TOWN OF YARMOUTH
200 Main Street, Yarmouth, Maine 04096
www.yarmouth.me.us

Planning Board Report
Shepley Weld Townhomes, 149 & 153 Main Street
Building & Lot Plan and Major Site Plan Amendment
Matt Wogan, Waypoint Partners, LLC, Applicant
Map 38 Lots 16 and 17-00A; CD4 Village Center
Prepared by: Erin Zwirko, Planning Director
Report Date: June 16, 2022; Planning Board Date: June 22, 2022

2018 Approved Site Plan

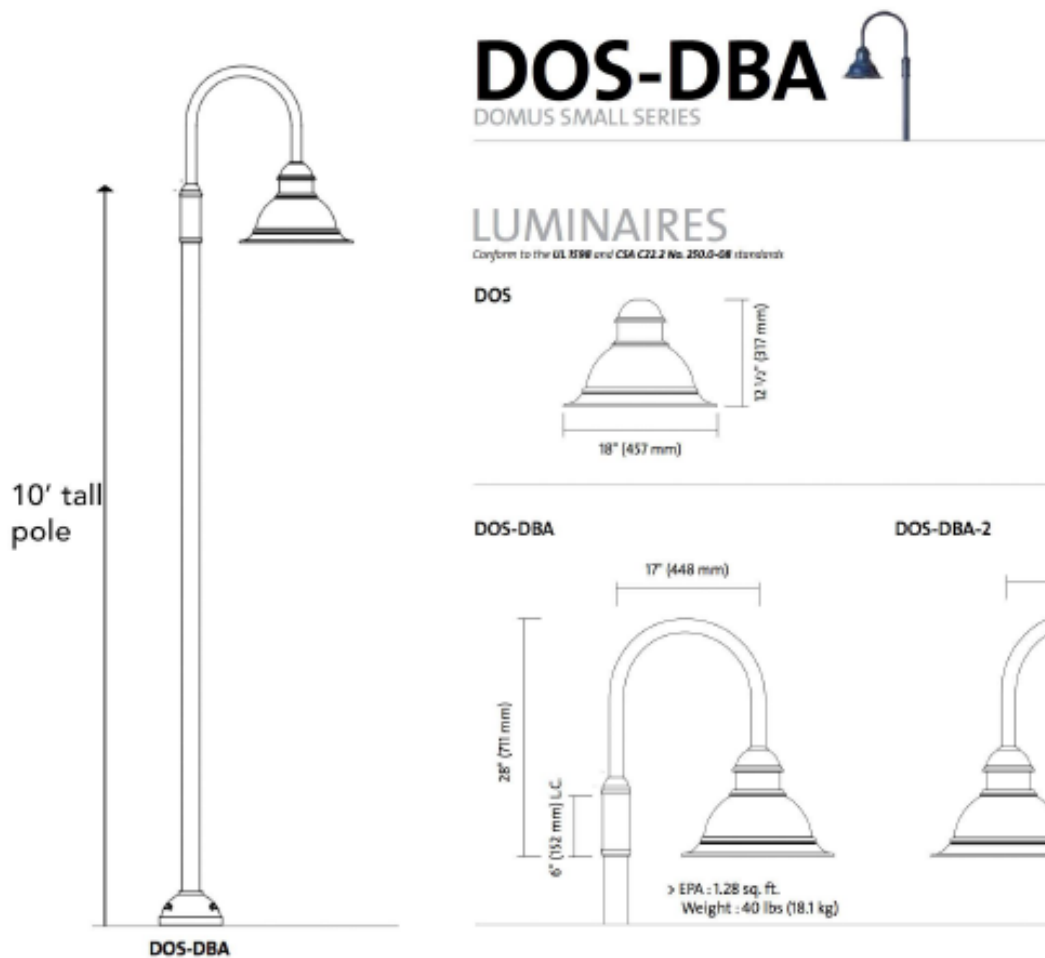
As part of the 2018 approval, a 10-foot light pole with gooseneck fixture was proposed to be located at the rear of the building to illuminate the parking area:

The applicant requests to replace the pole fixture with a wall sconce that is motion activated and mounted at 6 feet, an example of which was provided in the application materials:

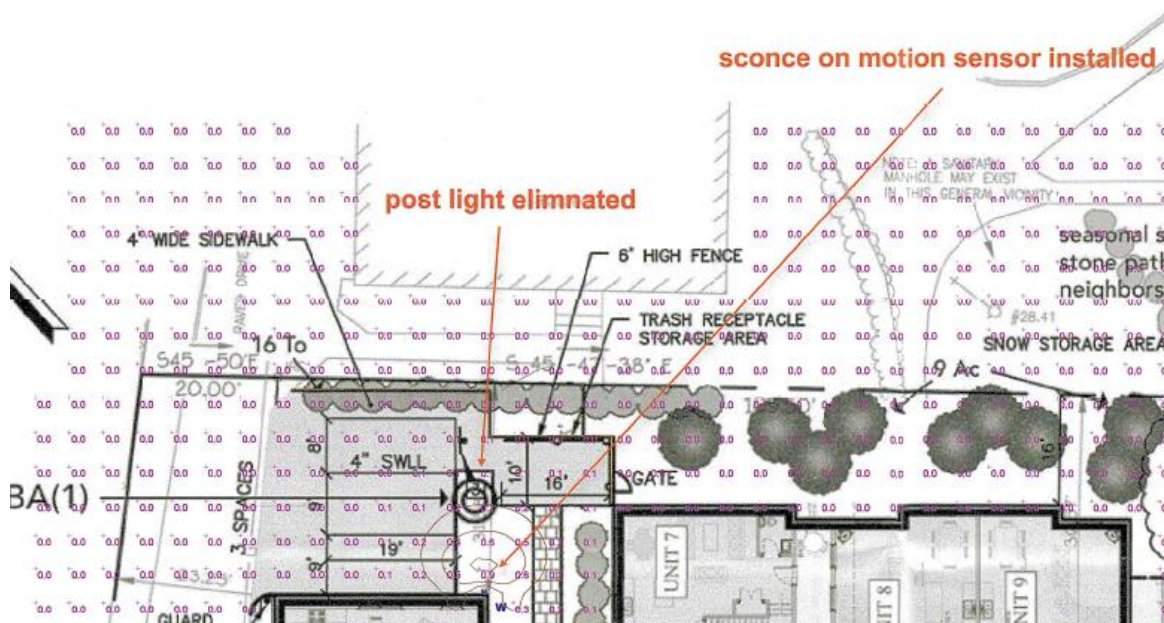
The following shall not be permitted... Exterior fluorescent lights, other than compact fluorescent lights in the incandescent spectrum... Colored light bulbs except seasonal displays... (Article 5.M.7.n)

The proposed wall sconce is consistent with this standard.
